ZONING AMENDMENT,
PLANNED UNIT DEVELOPMENT &
SUBDIVISION STAFF REPORT

Date: September 21, 2006

<u>NAME</u>	David R. Coley, III (Robert S. Coley, Agent)
<u>SUBDIVISION NAME</u>	Coley's Addition to Grelot Road Subdivision
<u>LOCATION</u>	Northeast and Northwest corners of Grelot Road and Somerby Drive
<u>CITY COUNCIL DISTRICT</u>	District 6
<u>PRESENT ZONING</u>	R-1, Single-Family Residential, R-3, Multi-Family Residential and B-2, Neighborhood Business
<u>PROPOSED ZONING</u>	R-3, Multi-Family Residential and B-2, Neighborhood Business
<u>AREA OF PROPERTY</u>	5 Lots/ 57.1± Acres
<u>CONTEMPLATED USE</u>	<p>Rezoning from R-1, Single-Family Residential and B-2, Neighborhood Business, to R-3, Multi-Family Residential district, to allow a residential apartment complex, and Planned Unit Development Approval to allow a 12-building, 316-unit apartment complex on a single building site.</p> <p>Rezoning from R-1, Single-Family Residential and R-3, Multi-Family Residential, to B-2, Neighborhood Business to allow an unspecified use.</p> <p>It should be noted, however, that any use permitted in the proposed district would be allowed at this location if the zoning is changed. Furthermore, the Pl

SITE PLAN

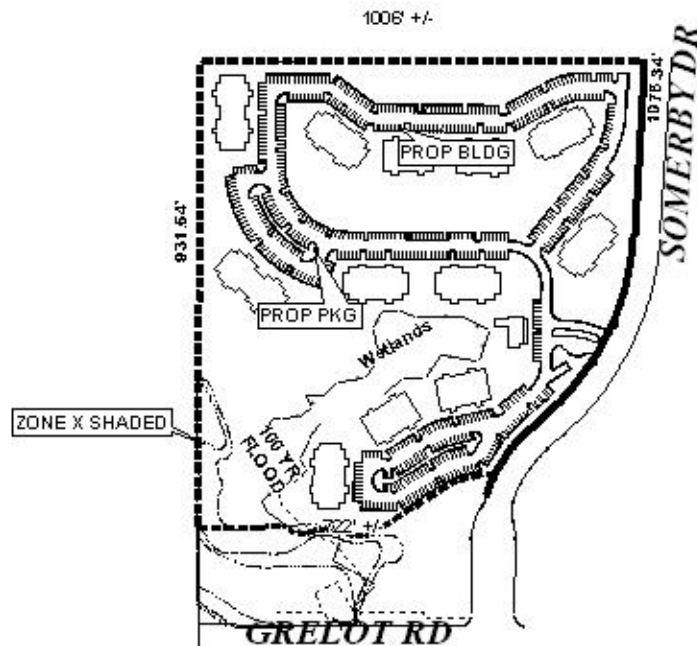
The site plan does not indicate the location of a stormwater detention basin, which may be required for the site due to new construction. A stormwater detention basin, sized to meet the requirements of the City's Storm Water Drainage Ordinance, must be indicated on the site plan if it is required. A note should be placed on the site plan, if approved, stating that maintenance of the detention basin common area, and any other common areas, are the responsibility of the development's property owners.

Conceptually, the development depicted on the proposed site/layout plan will minimize impacts to the potential residential and/or commercial development, especially with future development along Somerby Drive. It should be noted, however, that there is no indication on the site plan regarding the perimeter treatment of the property; specifically if a fence and/or landscape buffer will be provided to minimize impacts to adjacent lower-density residential development to the North. A privacy fence and landscape buffer is recommended for development on the North and East property lines. Furthermore, generalized landscaping proposed for the development should be depicted on the site plan, with the understanding that the final landscape plan will be more detailed and require approval by the Urban Forester.

The vehicular circulation depicts a 24-foot wide parking and maneuvering areas. The site would access with Somerby Drive and does illustrate a two-way, entrance with a landscaped median. However, depending on the Fire Department apparatus movement, the site may require two separate entrances. It should be noted that sidewalks are not illustrated, and would be required as each lot is developed.

SUBDIVISION PLAT

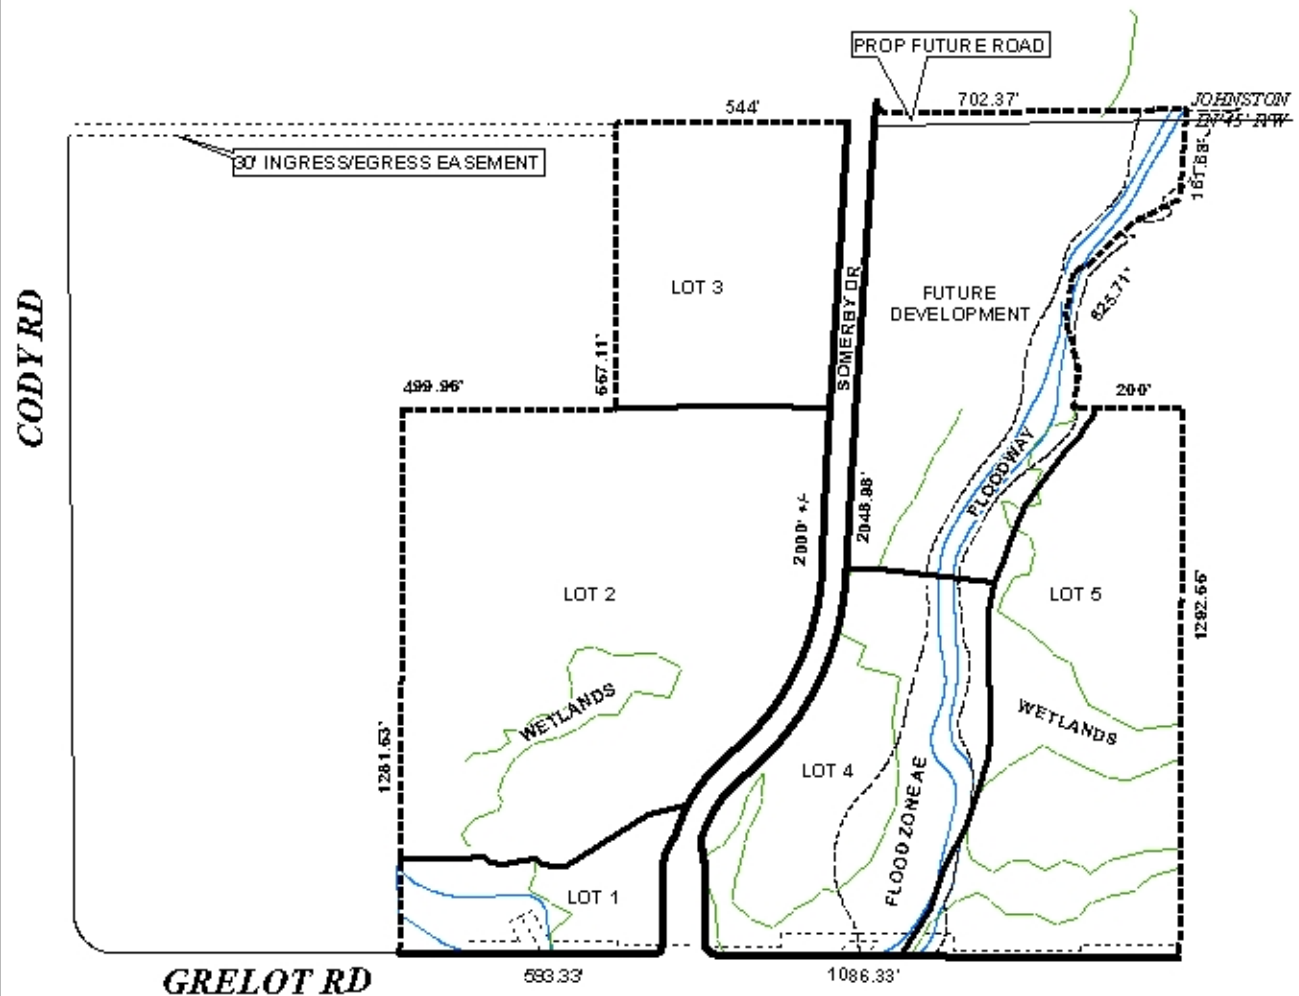
Finally, the minimum building setback line required in Section V.D.9. of the Subdivision Regulations is not shown for the overall lot, but would be required on the Final Plat.

Subdivision: The Subdivision request is recommended for Tentative Approval, subject to the following conditions: 1) depiction of the 25-foot minimum building setback line; 2) the placement of note on the final plat stating that Lot 1 be limited to one curb-cut onto Grelot Road (due to significant wetlands) and one curb-cut to Somerby Drive, Lot 2 be limited to two curb-cuts onto Somerby Drive, Lot 3 be limited to two curb-cuts to Somerby Drive, Lot 4 be limited to one curb-cut to Grelot Road and two curb-cuts to Somerby Drive, Lot 5 be limited to one curb-cut to Grelot Road, with the size, design and location of all curb-cuts be approved by the Traffic Engineering Department; and 3) completion of the rezoning process prior to the signing of the final plat.
